U. S. ARMY AC-1 DE HAVILLAND "CARIBOU" EVALUATION
Ft. Rucker, Alabama
21 January 1960

REPORT OF CRASH INJURY EVALUATION
A/CIR-14-PV-121
October 1960

United States Army
Transportation Research Command
Contract DA-44-177-TC-624

Figure 24. The instructions for the external operation of the cabin emergency exit under the left wing are inadequate for inexperienced rescue personnel. The arrow under the word PRESS should point towards the button.

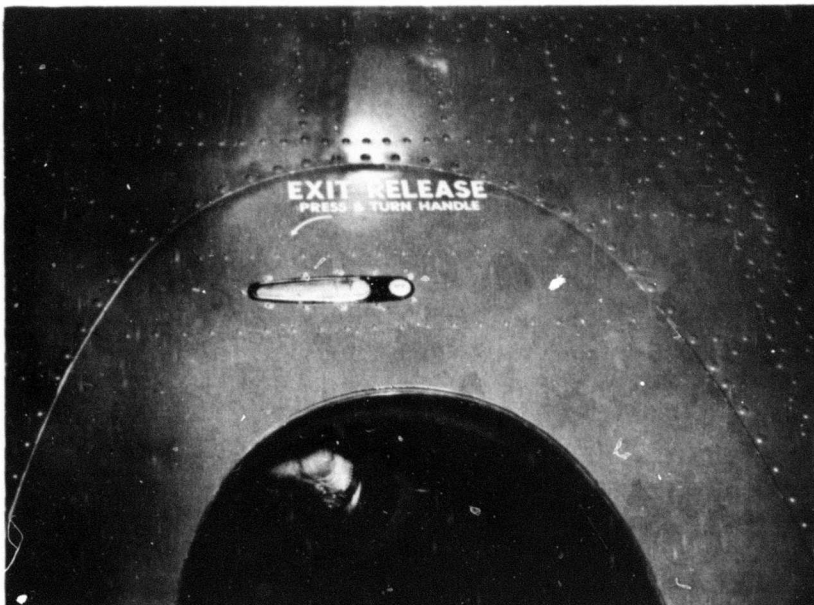
The instructions for the outside release of the emergency exit under the left wing are ambiguous. The instructions read: PRESS AND TURN HANDLE, while an arrow from the word "PRESS" points toward one side of the handle (Figure 24). Actually, the button that must be pressed first is located on the other side of the handle. Since this emergency exit release may be operated by inexperienced rescuers, thought should be given to less ambiguous instructions and a more direct way of operation.

Although elimination of this button would increase the chance of inadvertent operation, this would not be a serious hazard since it can be done only while the aircraft is on the ground.

2. If these buttons are to be maintained the related instructions be made more explicit and leave no doubt regarding sequence of operation and location of button.
3. The doors on opposite sides at the aft end of the cabin be made jettisonable.
4. The relocation of the troop seats with respect to the forward emergency exit (or vice versa) and the exit release handle be considered in order to determine the practicability of making this exit usable without removal of seat structure.
5. An extra emergency exit be added to the right cabin wall and that its location and design be governed by Recommendation 4 above.
